**ADDENDUM NO. 4
TO THE BID DOCUMENTS**

Project: Homer Harbor Facilities Improvements - 2014
Addendum Issue Date: December 20, 2013
Bid Date: **January 16, 2014@ 2:00 PM (Thursday)**
Previous Addenda Issued: 3 (Three)
Issued By: Dan Nelsen
Public Works Project Manager
City of Homer
Homer, AK 99603
dnelsen@ci.homer.ak.us

1 ELECTRICAL REMODEL PLAN
1" = 40'-0"

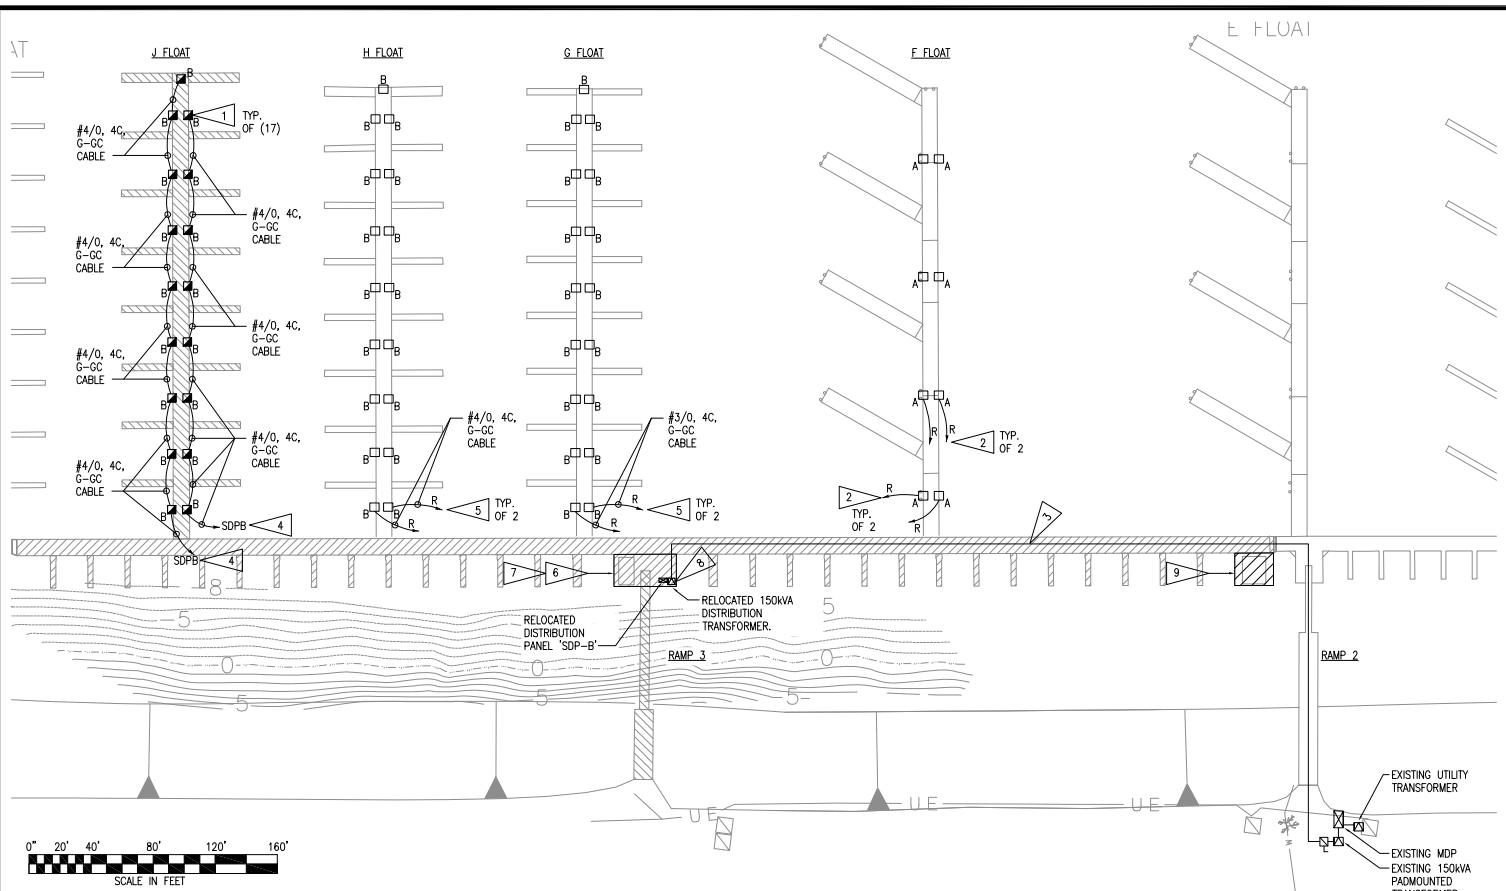
ITEM 1 – There are two sheds, one on the landing float at ramp 3 in bid item 16000.1, and one shown on sheet E3 at ramp 2, 160001.AA1 Add Alt . The one at ramp 3 we will call the ‘skinny’ shed for the purpose of explanation. Sheet E5 shows a shed that is different than the skinny shed. It appears to be have a squarer shape more than a rectangular shape. I wanted to have this clarified as Panel ‘S3’ is to be mounted in this shed. Please clarify where ‘S3’ is to be installed. E5 shows Panel ‘S3’ mounted the wall 90 degrees from the man door whereas on Sheet 39 of 53 in the drawings, there is a man door at the location where ‘S3’ would be.

ITEM 2 - Panel ‘S2’ is fed from Panel ‘S3’, and we cannot determine where Panel ‘S2’ is to be installed / located. The only place that ‘S2’ shows up on the drawings is on the one-line sheet, E1, and panel schedule E5.

ANSWER: See attached plan revisions for sheets E3 and E5.

ANSWER: See attached plan revisions for sheets E3 and E5.

9. PROVIDE CONNECTION FOR NEW SHED UNDER ALTERNATE #1 SIMILAR TO RAMP 3 SHED. SEE 2/E5. PROVIDE AND INSTALL NEW PANEL "S2" IN RAMP 2 SHED.
